# Berens Park

Berens Park is very large neighborhood park that provides miniature golf, splash pad, playgrounds, soccer fields, football fields, batting cages, restrooms, and an extensive walkway system. The main issues at this park are not having proper parking spaces, slope issues, counters too high, not proper drinking fountains, door opening force being too high, protruding branches, lack of pipe protection, and signage not of the proper type or location. **Please Note:** When a **UD** is indicated, this is a Universal Design (**UD**) recommendation to enhance accessibility. The **UD** recommendation is not required to meet the minimum accessibility standards but it would be encouraged.

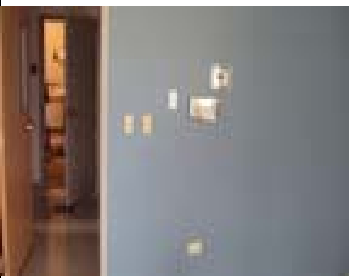
The mat at the Hub entrance door is too light and could be a tripping hazard.	ADAAG 302.2	Provide a mat with a heavier backing or tape the mat to the floor.			\$150	2012	Replaced mat 1/28/12

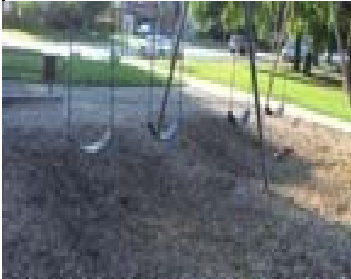
The men's restroom sink does not provide pipe wrap.	ADAAG 606.5	Provide protective pipe wrapping on the water shut offs and drain pipes.		Bob Byrne	\$75	2014	Provided protective pipe wrap 3/21/2014

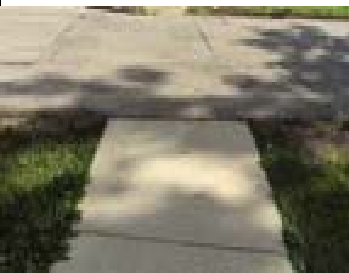
The east ramp into the playground has an abrupt transition of 3 1/4"	ADAAG 1008.2.5	Provide a ramp extension or transition plate from the ramp to the playground surface with a running slope no steeper than 8.3% and an cross slope no steeper than 2%.			" " " "	2012 Capital Plan	Replaced Playground equip., and surfacing \$177,00 for entire project
